**Technical Service
Information Bulletin**

INSTRUMENT PANEL RATTLE

'04 – '06 RX 330, '06 RX 400h, & '07 RX 350

NVH
NV002-06

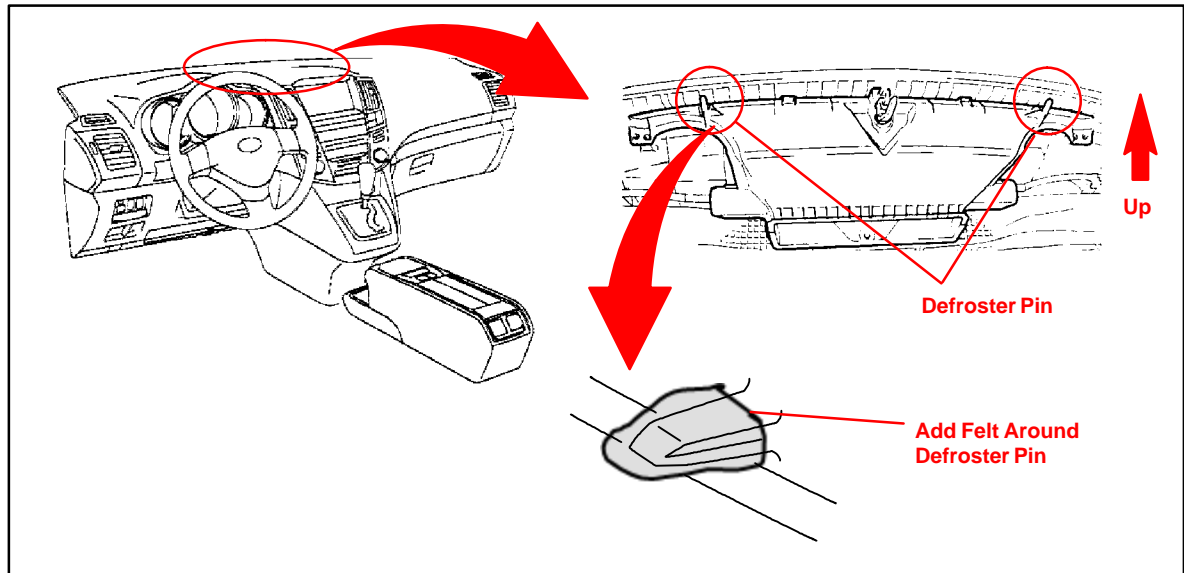
1. Follow the precautions and instructions to remove the dash pad sub-assembly as identified in the Technical Information System (TIS), applicable model and year Repair Manual: *Instrument Panel/Meter, Instrument Panel Safety Pad Sub-Assembly, Precaution and Replacement*.
2. Pull back the dash pad sub-assembly to expose the defroster nozzle assembly and its 2 locating pins.
3. Apply felt over the pins as shown in the diagram to take up excess slack inside the body holes.
Felt Size:
Length: 55 mm (2.2 in.)
Width: 13 mm (0.6 in.)
Thickness: 1.5 mm (0.1 in.)
4. Reassemble the dash pad sub-assembly.
